TPC Summerlin - Turf Modification

CITY OF LAS VEGAS		DATE:
INTER-OFFICE MEMORANDUM		June 27, 2018
TO: Land Development Services Department of Building & Safety		FROM: Albert Sung, P.E. Flood Control Project Engineer Department of Public Works
SUBJECT:	Drainage Study for:	COPIES TO:
	TPC Summerlin – Turf Modification	GCW Engineers / Surveyors
Cross Streets:	NWC of Summerlin Pkwy. & Rampart Blvd.	Tournament Players Club
File Number:	F:\Depot\DSMemos\DS5006A.doc	Bart Anderson, P.E., DevCo
Parcel Number:	138-20-413-017 & 138-29-310-001	CCRFCD
Zoning Action:	SDR-xxxxx	
FEMA Flood Zone	YES NO X	
Proposed Storm Drain	YES NO X

**TECHNICAL DRAINAGE STUDY
FOR
TPC Summerlin**

FIGURE 5
DRAINAGE PATTERNS
& IMPROVEMENTS

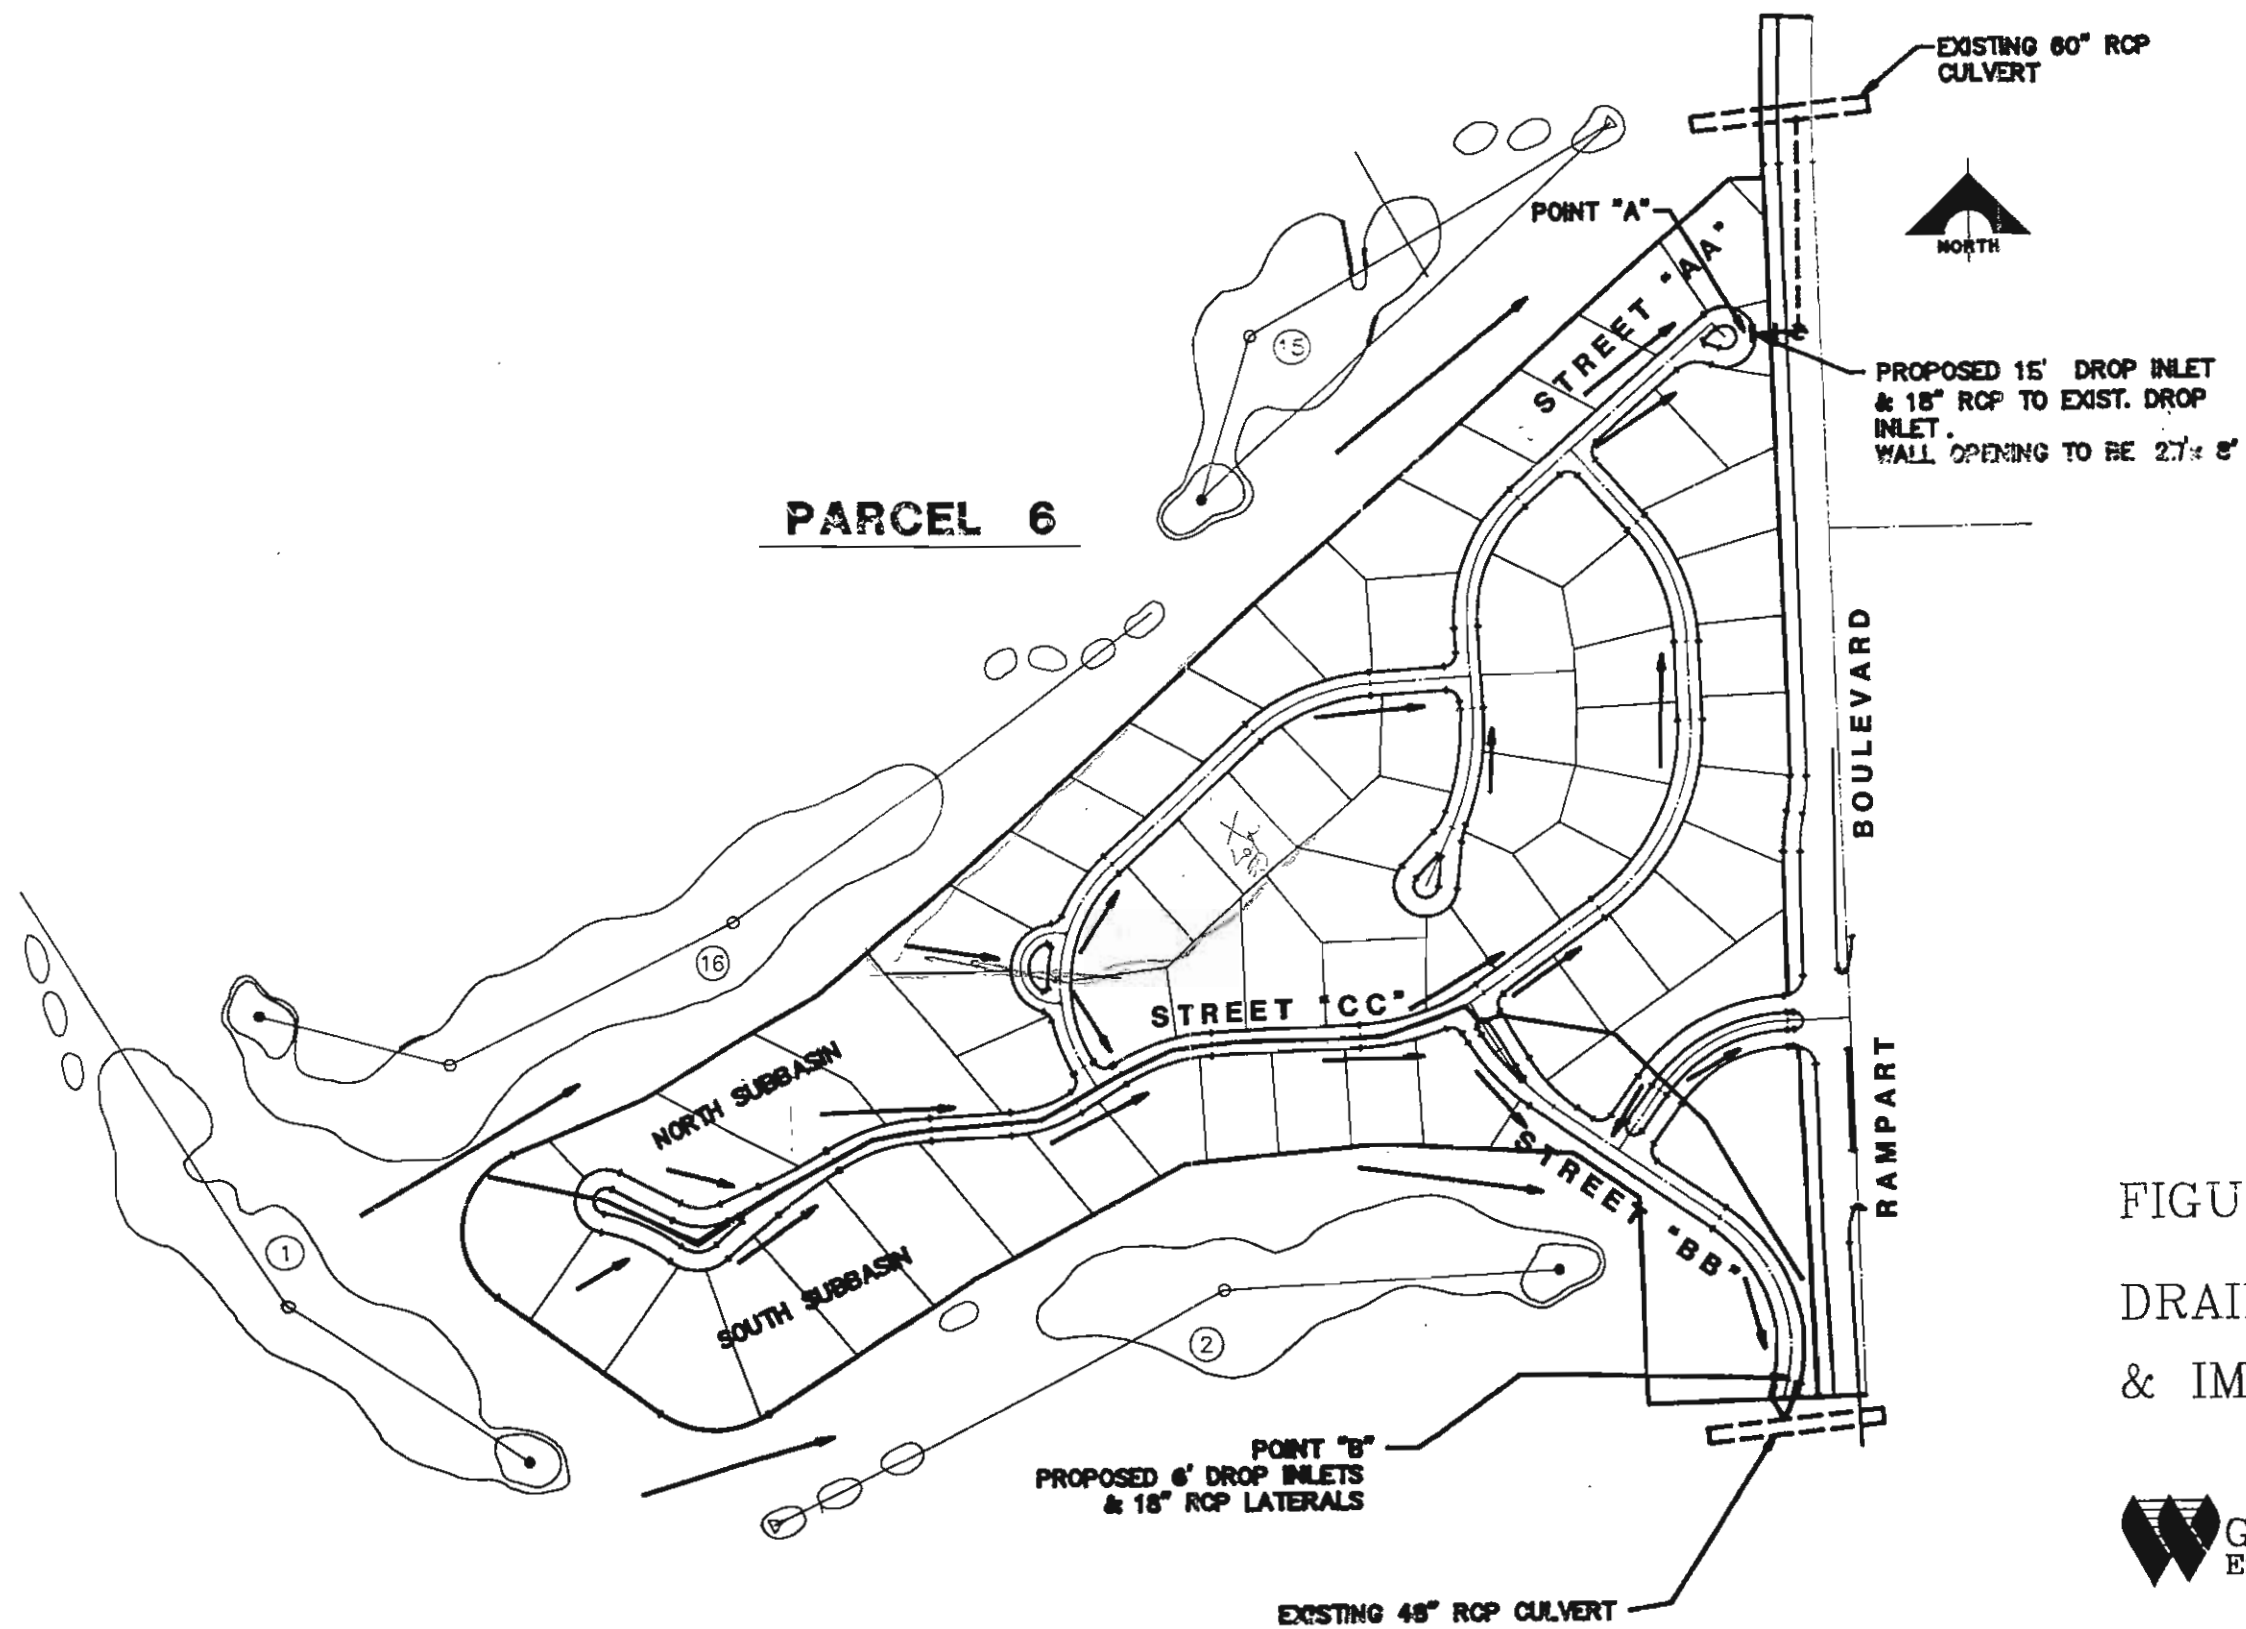
3. **Figure 5:** *Hydraulic Section 6* is nowhere to be found on the drainage map. Identify clearly in the next submittal.
4. Provide grading plan with table to detail the locations, exact quantities/dimensions of the grass to be replaced with desert landscaping with respect to the Sections or channel stationings.
